ONE CHASE MANHATTAN PLAZA  
NEW YORK, N. Y. 10005WASHINGTON TELEPHONE:  
202 FEDERAL 8-0111ARVIN E. UPTON  
EUGENE B. THOMAS, JR.  
LEONARD M. TROSTEN  
WASHINGTON PARTNERSAngus Macbeth, Esq.  
Natural Resources Defense  
Council, Inc.  
36 West 44th Street  
New York, New York 10036Re: Consolidated Edison Company  
of New York, Inc.  
Indian Point Unit No. 2  
AEC Docket No. 50-247

Responses to Questions Supplied by Hudson River Fishermen's  
Association on October 22, 1971.

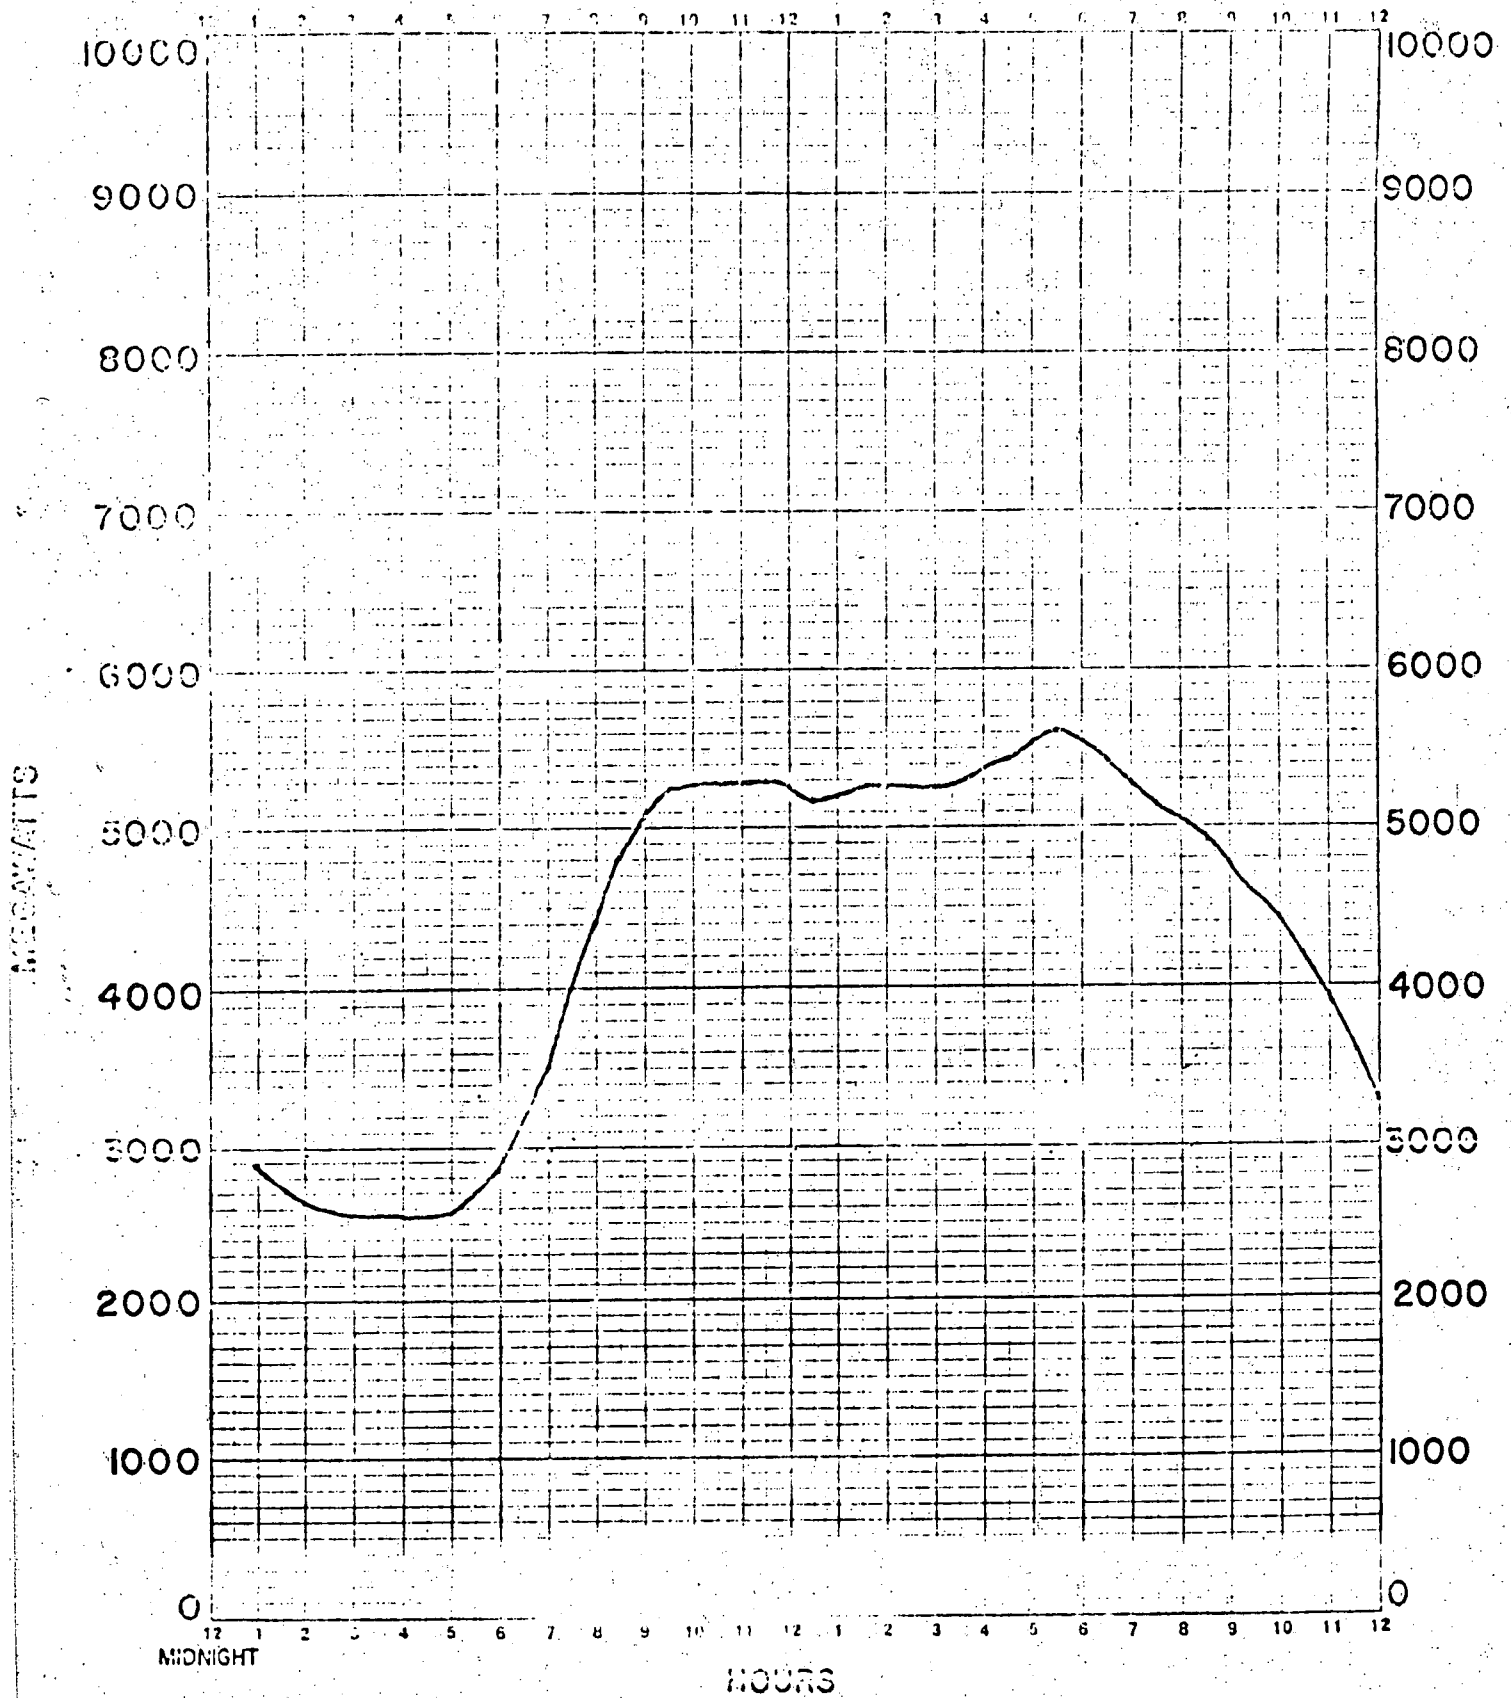
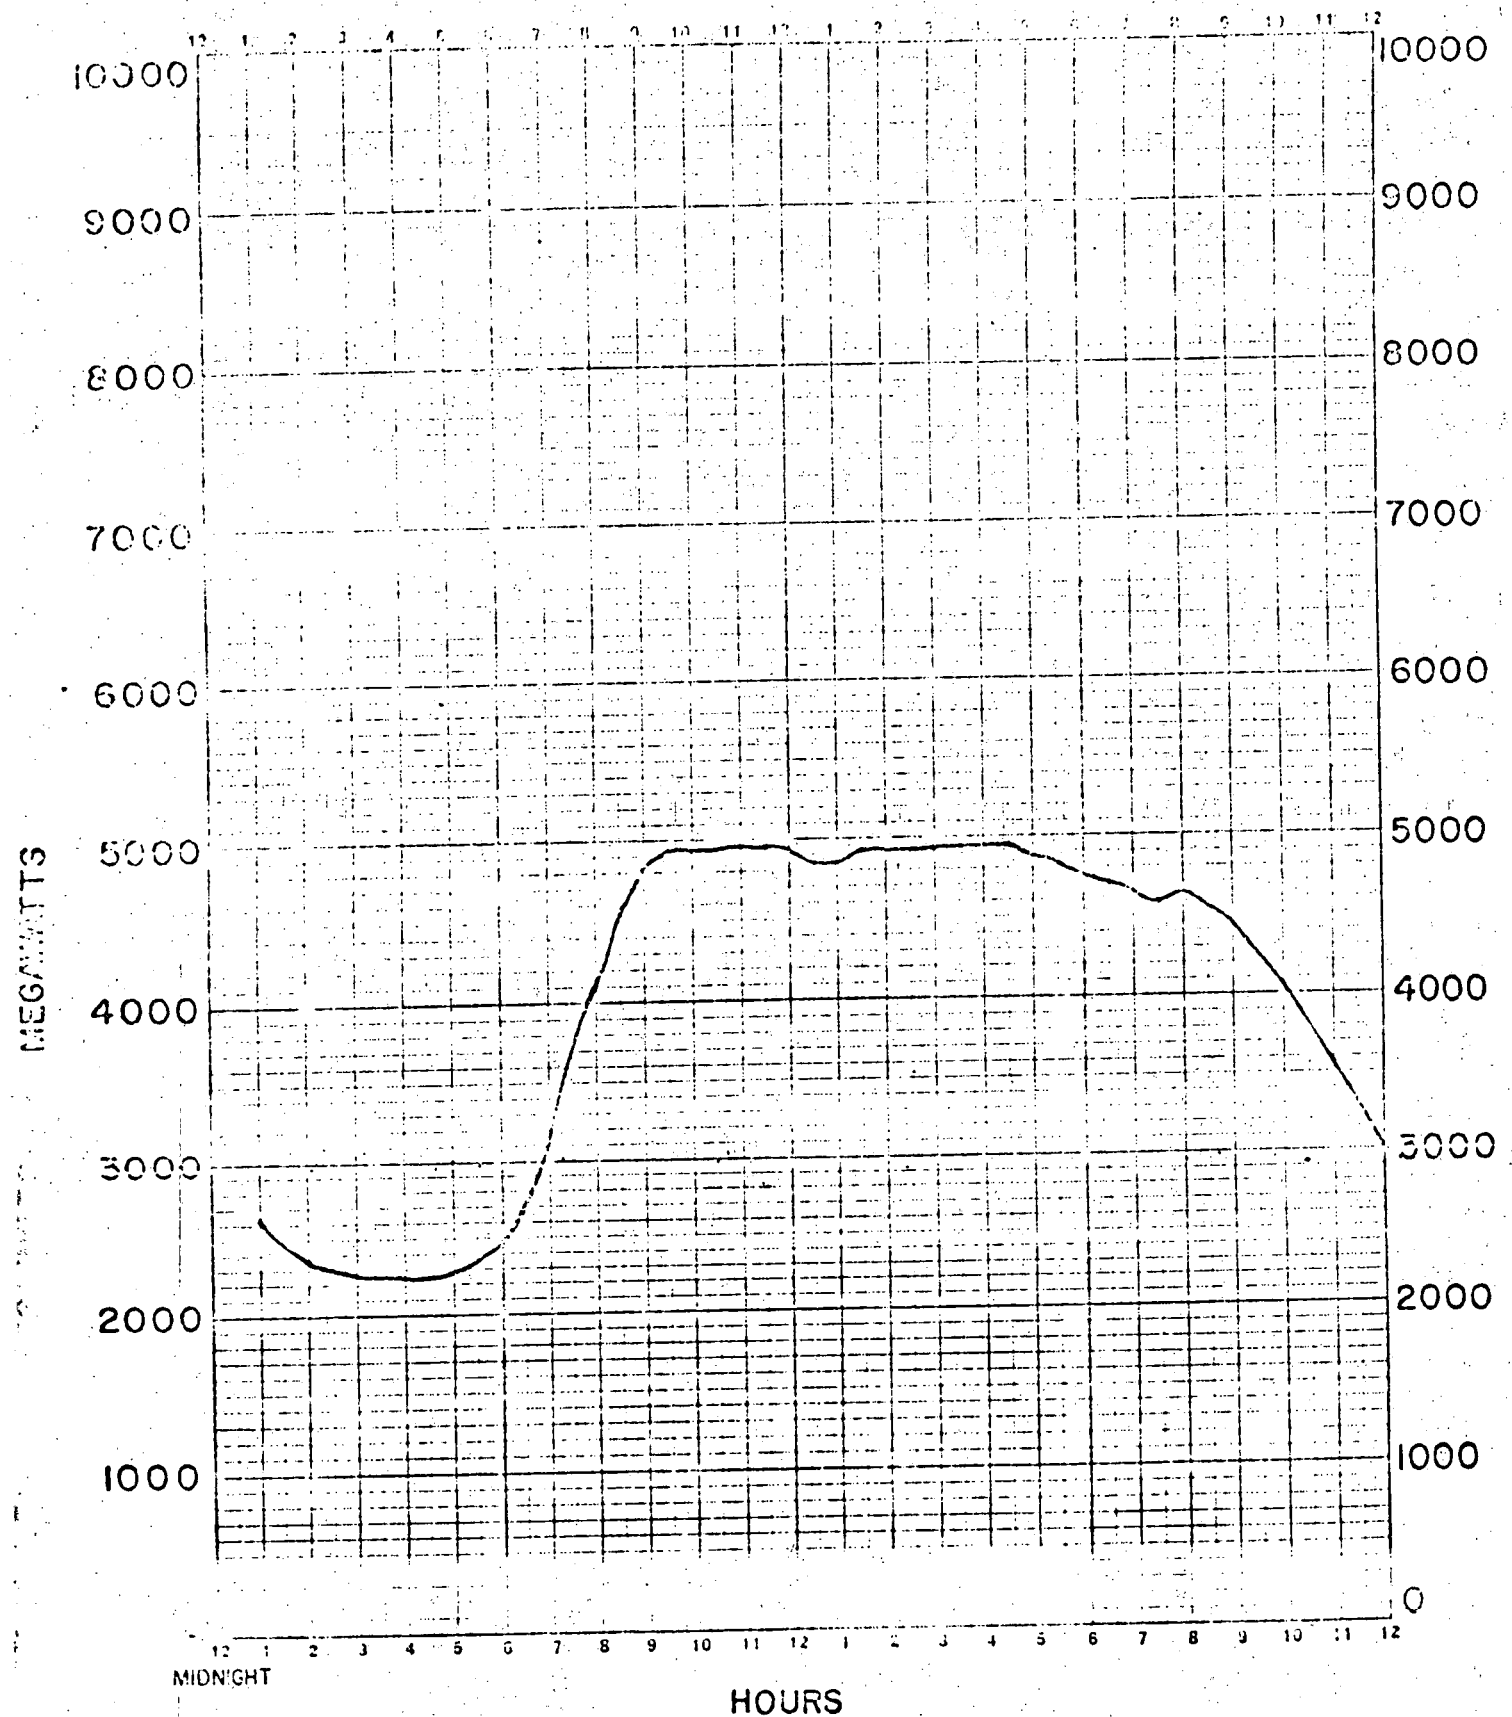
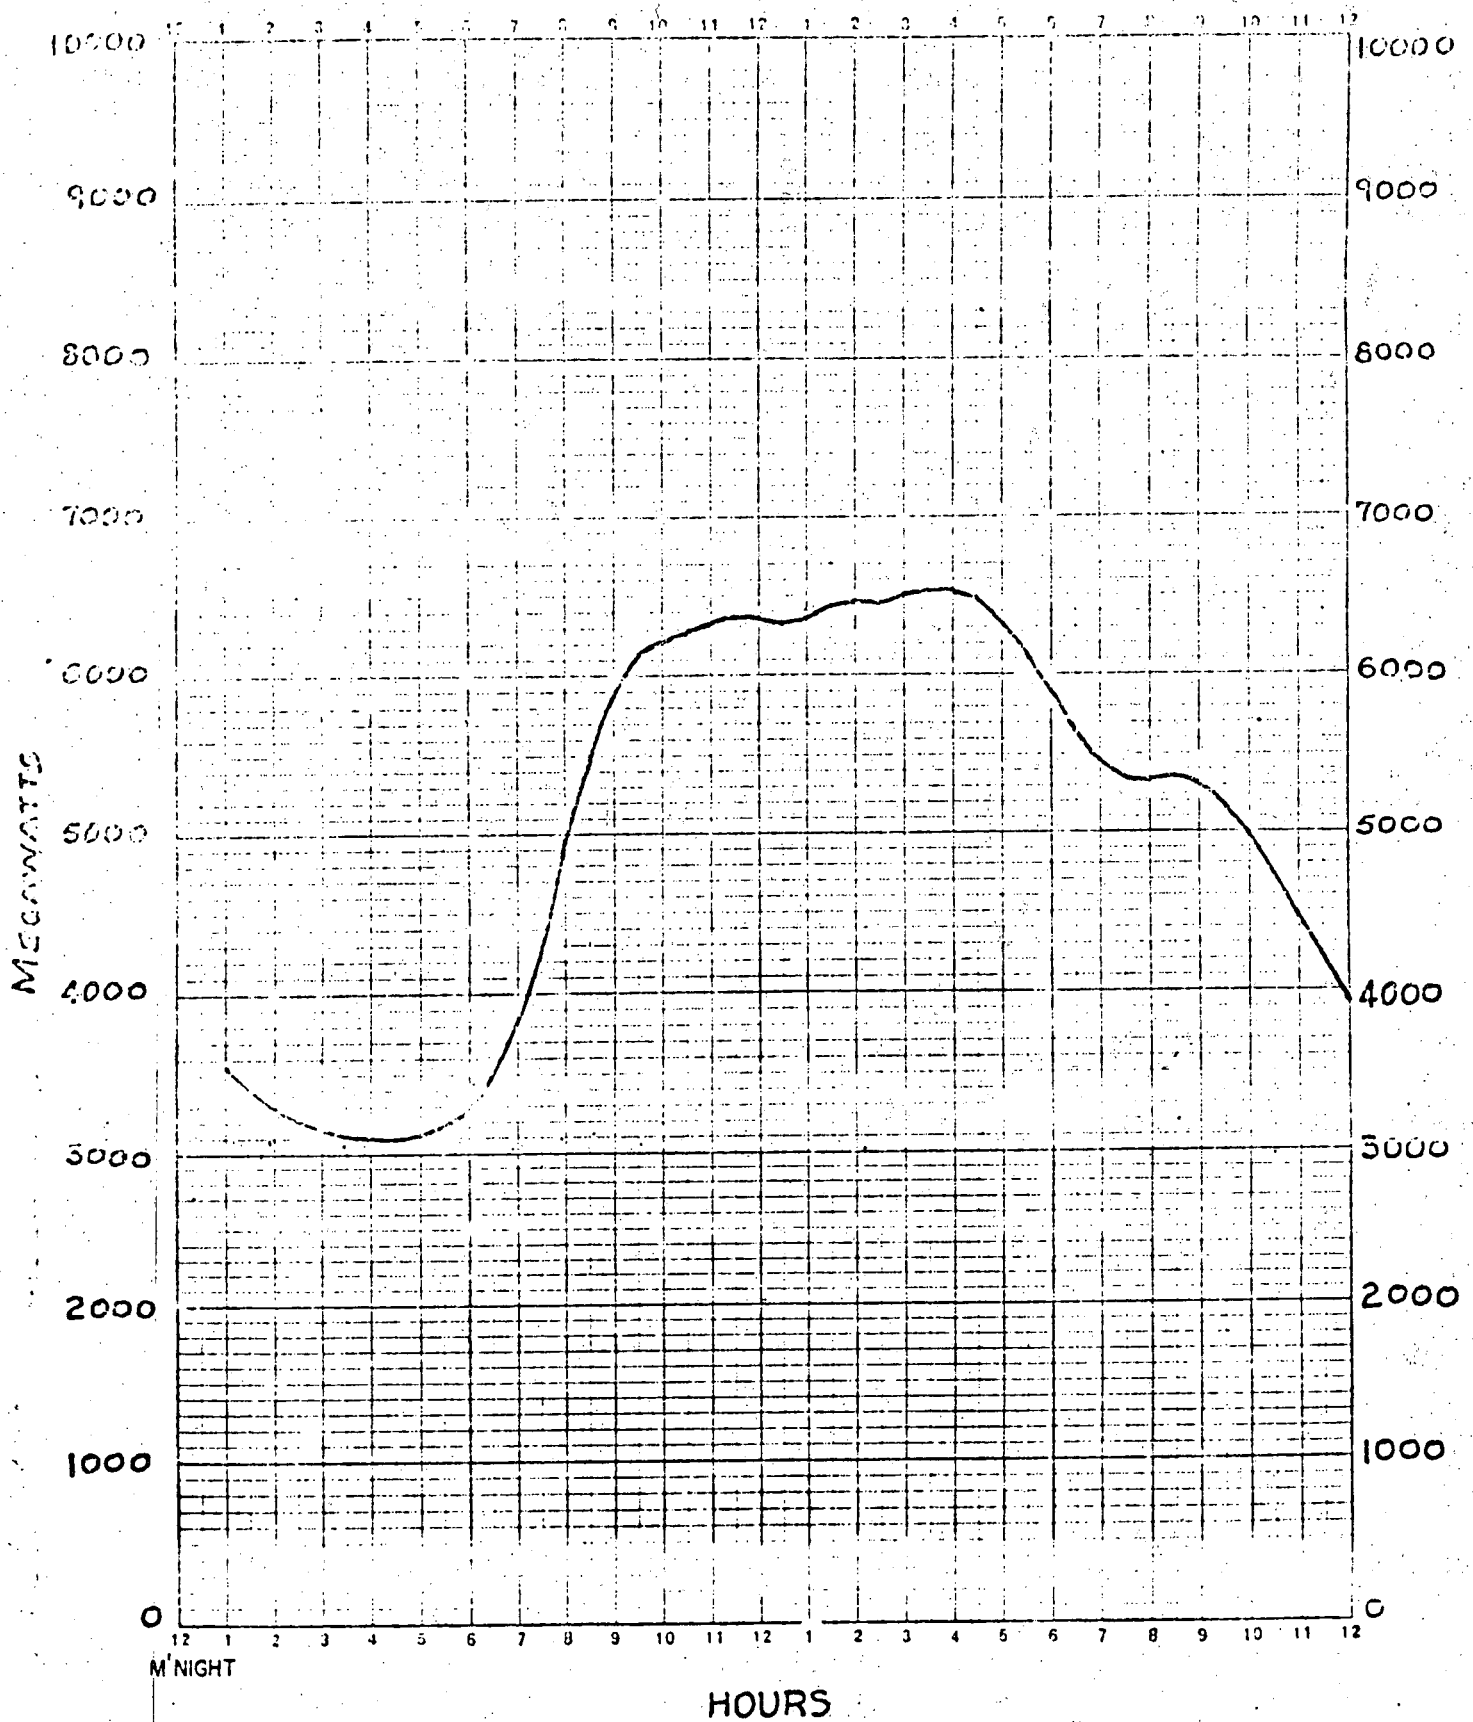
3. What are the present power demands in the entire Consolidated Edison system, on an hour by hour basis, during the course of an average day in a) January b) April c) August d) October? A graphical presentation of these data showing twenty-four (24) hour continuous demands would be most useful.

The attached graphs, Figures 3-1, 3-2, 3-3 and 3-4, indicate on an hour by hour basis the loads on an average day in October 1970, January, 1971, April, 1971 and August, 1971, respectively.
